DOCUMENT REVIEW ASSESSING THE
SUITABILITY OF USING HDD THROUGH QUEEN
ELIZABETH PARK AS PART OF THE SLP
PROJECT

Project Reference: GDS1952

Client: Rushmoor Borough Council

Document Version: 1

Figure 1 – Current proposals for pipeline installation through QEP section of the SLP pipeline route

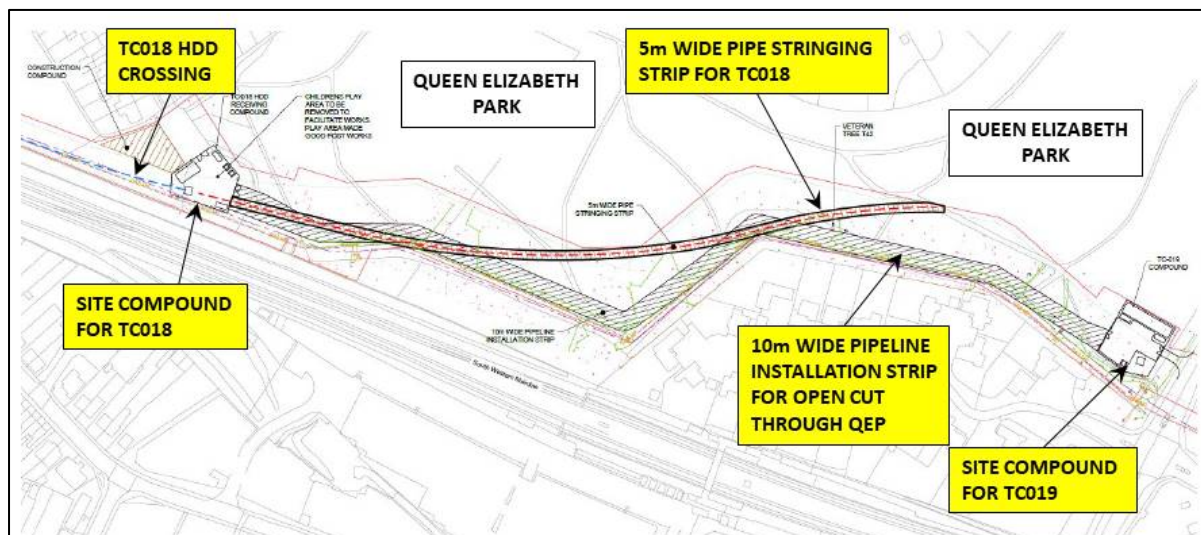
Currently, the SLP project plans to use the conventional open cut method for pipeline installation to cross the park area at QEP. The project is proposing a narrow working corridor through the QEP area to limit the impact on the park and existing precious trees, and to minimise disturbance of the park during pipeline construction activities, although access for park users may be reduced significantly. It is also proposed to use the QEP park area for pipeline stringing on the adjacent TC018 HDD crossing.

Figure 1 below is based on Figure 1.1 from Reference [1] and shows what are believed to be the current proposals for pipeline installation through QEP, and current proposals for pipeline stringing operations at the adjacent TC018 HDD crossing. The HDD exit point site compound for TC018 is shown on the western end of the proposed pipeline route through QEP. A site compound for the TC019 crossing (augerbore crossing of the A325 road) is shown on the eastern end of the proposed route through QEP.
